Levy Nuclear Plant, Units 1 & 2

COL Application

Technical Specifications

**Levy Nuclear Plant Units 1 and 2
COL Application
Part 4, Technical Specifications**

FIGURE 4.1-1 Site and Exclusion Boundaries

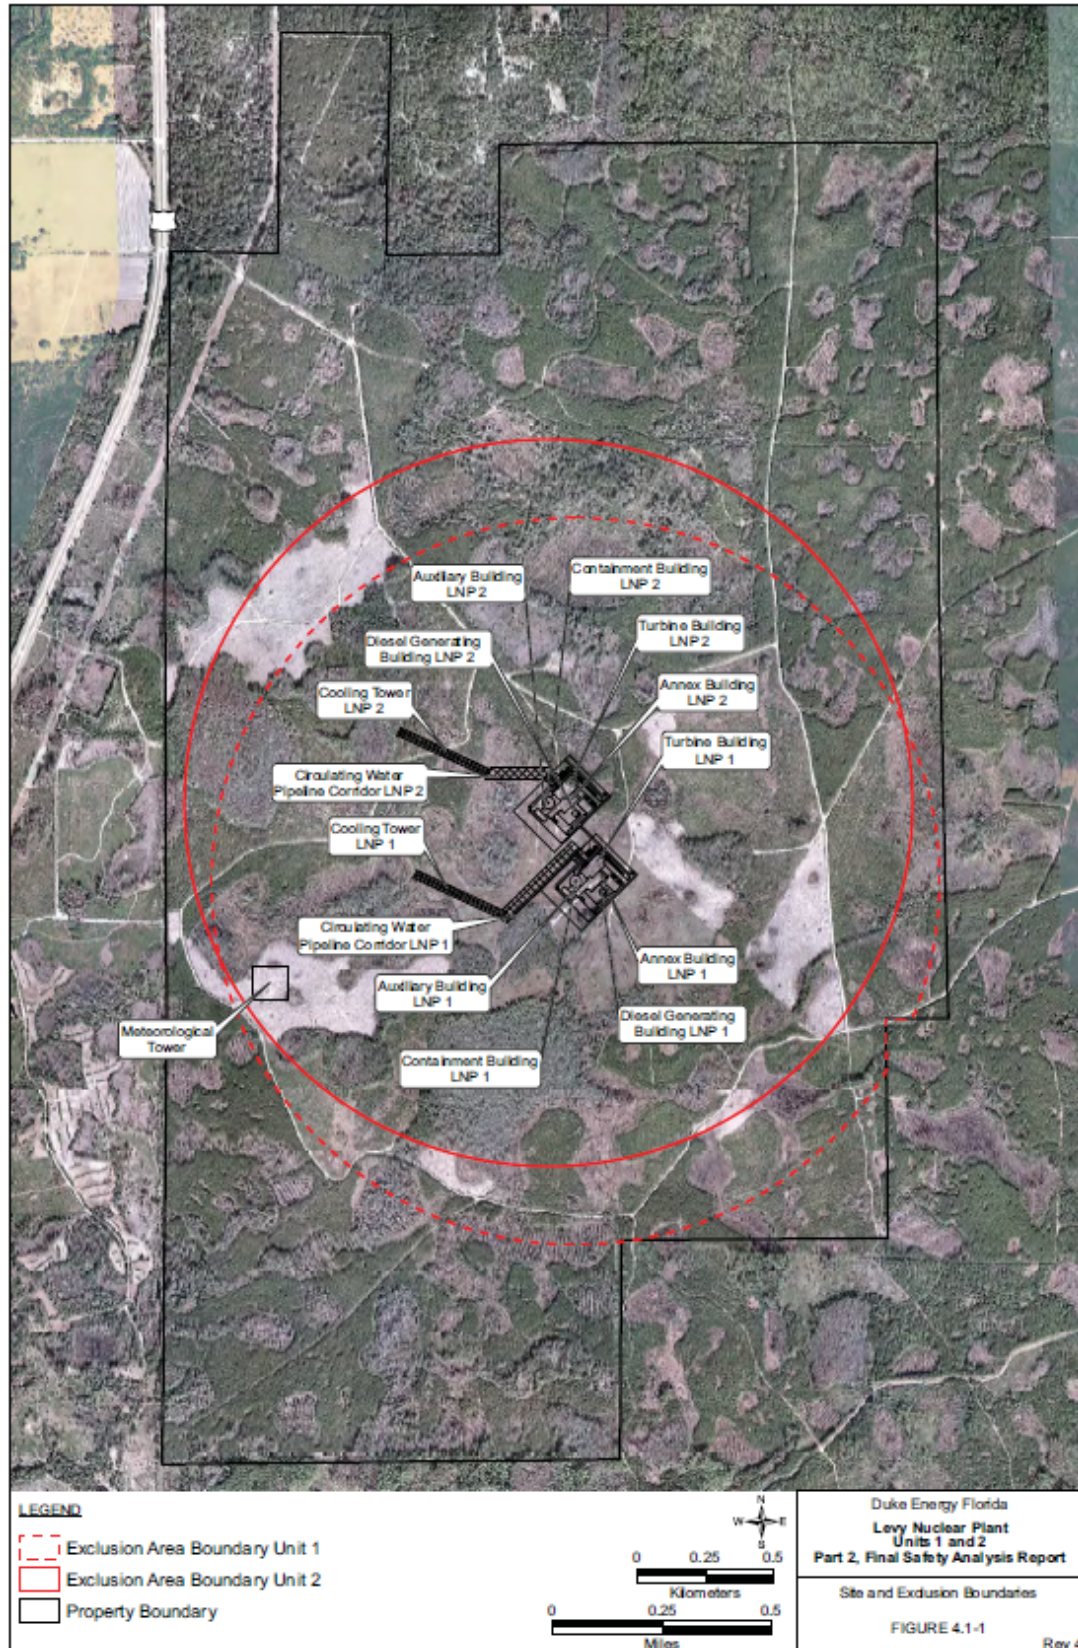
GTS 4.1.1 The bracketed information in the GTS reads:
[This information will be provided by the combined license applicant.]

Replace the bracketed information in the GTS with the following:
The Site and Exclusion Area Boundaries are shown in Figure 4.1-1.

Justification:
Bracketed information is replaced to establish Site Boundary and Exclusion Area Boundary for LNP consistent with the descriptions identified in FSAR Sections 2.1.1.2 and 2.1.1.3.

FIGURE 4.1-2 Low Population Zone (LPZ)

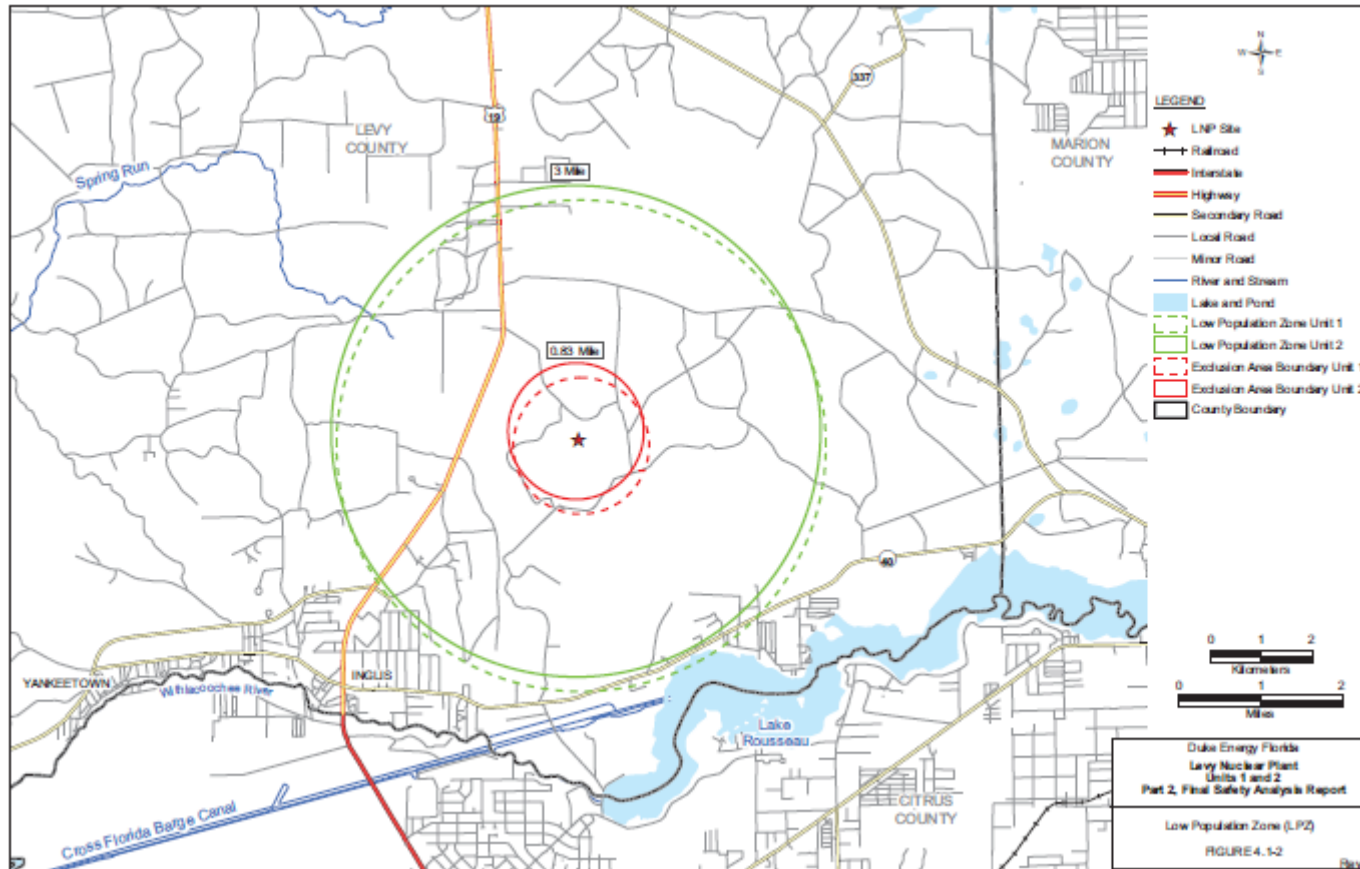
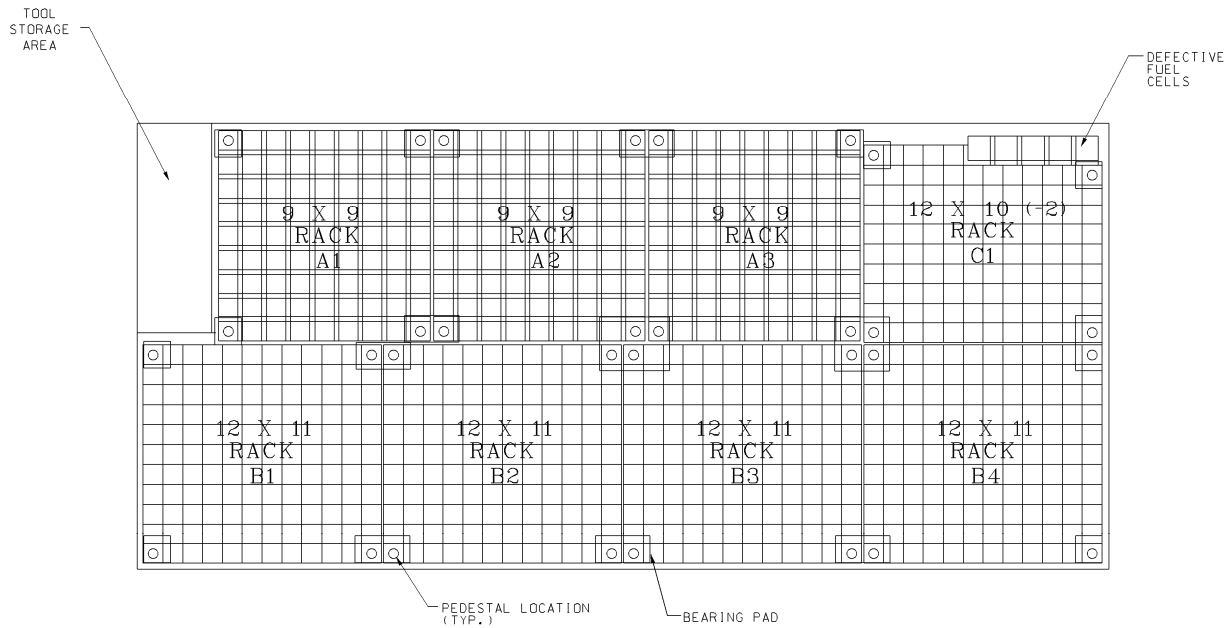
GTS 4.1.2 The bracketed information in the GTS reads:
[This information will be provided by the combined license applicant.]

Replace the bracketed information in the GTS with the following:
The LPZ is defined by the 3 mile radius from the site center point as shown in Figure 4.1-2.

Bracketed information is replaced to establish the LPZ for LNP consistent with the descriptions identified in FSAR Section 2.1.3.4.

Figure B 3.6.8-1 (page 1 of 1)
Time Prior to Coolant Inventory Boiling

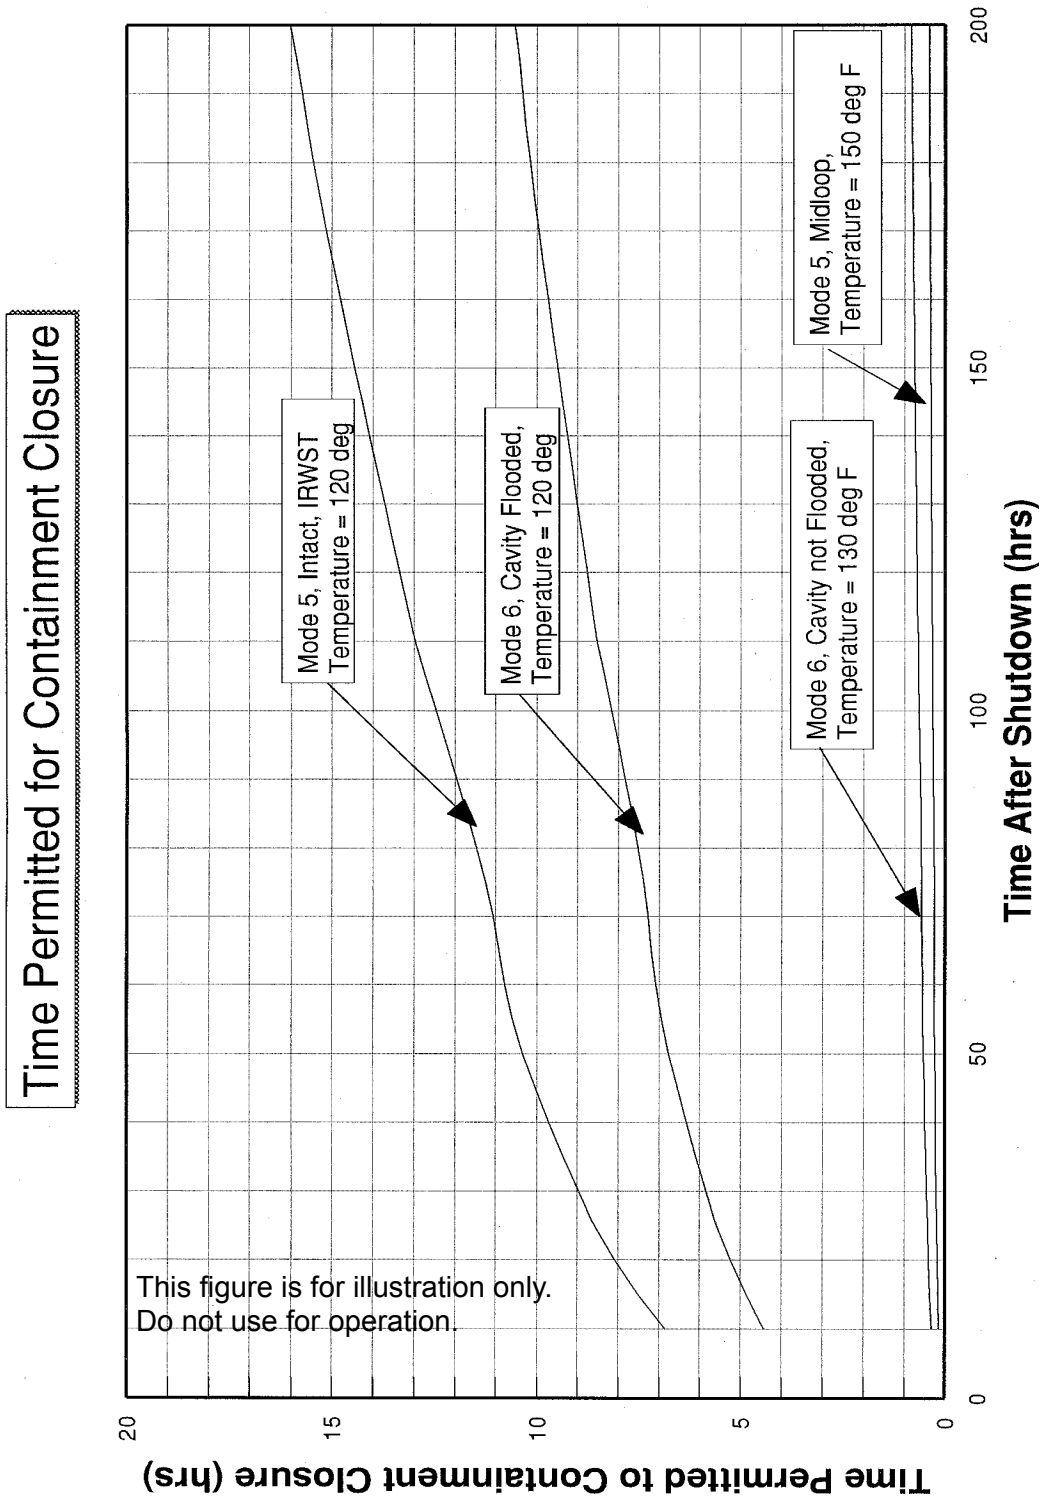
- GTS B3.6.8 The Bases for Specification 3.6.8 contain a bracketed figure which addresses the anticipated time prior to coolant inventory boiling under various conditions.

Remove the reviewer note in the PSTS. There is no replacement language.
